Software release (UCCSuite 4.4)

UCCServer 4.30.11

Diagram of Zone to determine PtMeas Touch type override conditions

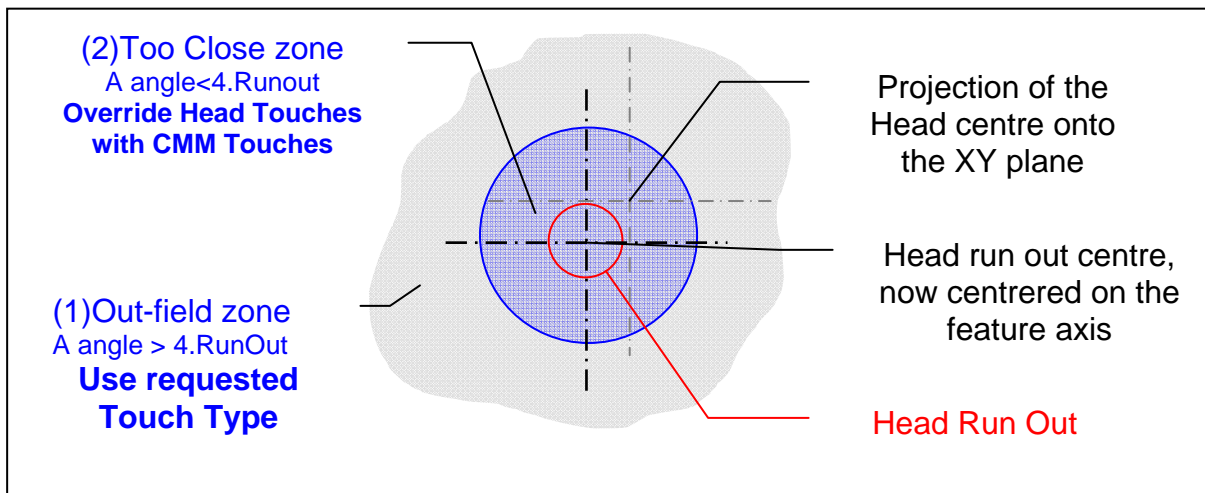
PH20 Small vertical bores use CMM touch – Issues of run-out of the tip exist when measuring in a small vertical bore. When measuring small bores, if the Quill is kept on the centre axis, it is possible for the tip to collide with the bore while rotating to the next position. To overcome this problem a central zone is defined where the A axis is near to 0 degrees. In this zone the FixedQuill or AllAxes Head Touches are overridden by FixedHead touches. Outside of this zone then all touch types are executed as requested. This override function is designed to resolve issues with small bore measurement and measurements where the B axis is

not facing the surface again with A near 0. The system cannot distinguish between points in a bore, or just on a plane. It has therefore been necessary for the override test to be conducted on all PtMeas requests, whether in a bore or not.

The zone is determined by a combination of the RunOut of the head. (Runout is calculated internally from the Head calibration data) and a multiplier parameter (see below) The test of zone is calculated based on the PtMeas Approach point. The parameters to control the multiplier for the zone are found in the UCCserver.ini File and are :-

```
[HeadTouch]
TooCloseZoneMultiplier=4
MidZoneMultiplier= 4
```

NOTE – These parameters should both be set to the same value – the default is 4. By setting the values to 0, this function is turned off.
